Access Compliance Report

Public Rights-of-Way

Intersection ID: 11757	Main Street: PLOTT_RD	Cross Street: SILVERWOOD_LN	Location: S
ADA ID: AEF58629EEA4	Ramp Type: BlendTrans1	Initial Pass/Fail: Fail	Overall Compliance: No
		Severity Score: 42.5

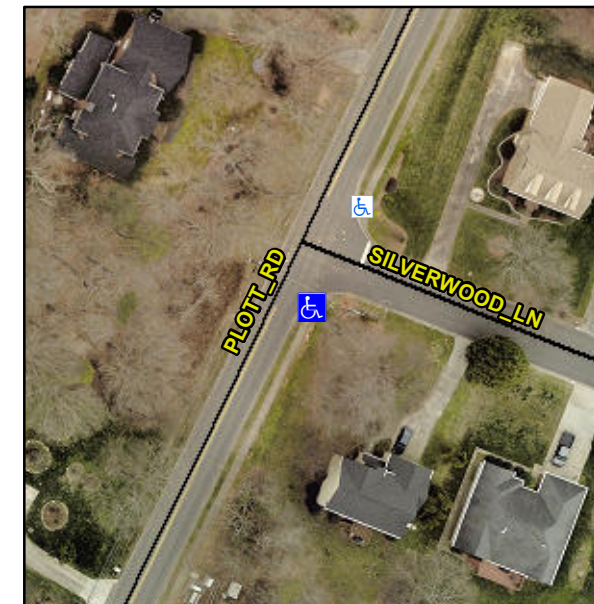
Not Found, R304.5.1, R304.5.3

Compliance	Description	Data	Compliance	Description	Data
N/A	Ramp Length (in)	150.0	Yes	BlendTrans Slope (%)	4.4
No	Ramp Width (in)	33.0	No	BlendTrans XSlope (%)	10.2
N/A	Flare Type LT	N/A	N/A	Flare Type RT	N/A
N/A	Flare Slope LT (%)	N/A	N/A	Flare Slope RT (%)	N/A
N/A	Flare Traversable LT?	N/A	N/A	Flare Traversable RT?	N/A
N/A	Landing Length (in)	N/A	N/A	DWS Provided?	N/A
N/A	Landing Width (in)	N/A	N/A	DWS Contrast?	N/A
N/A	Landing Slope (%)	N/A	N/A	DWS Length (in)	N/A
N/A	Landing X Slope (%)	N/A	N/A	DWS Full Width?	N/A
N/A	Landing Curb? (Y/N)	N/A	N/A	DWS Offset (in)	N/A
N/A	Shared Landing?	N/A			
N/A	Gutter Ponding?	N/A	N/A	Gutter Slope (%)	N/A
N/A	Gutter Lip Ht (in)	1.0	N/A	Gutter X Slope (%)	N/A
N/A	Painted X Walk1?	No	N/A	Painted X Walk2?	N/A
	X Walk 1 Direction	To NE		X Walk 2 Direction	N/A
	X Walk 1 Width (in)	N/A		X Walk 2 Width (in)	N/A
	X Walk 1 Slope (%)	1.5		X Walk 2 Slope (%)	N/A
	X Walk 1 X Slope (%)	3.1		X Walk 2 X Slope (%)	N/A

Remove & Replace Curb Ramp With Two New Directional Ramps or Equivalent.
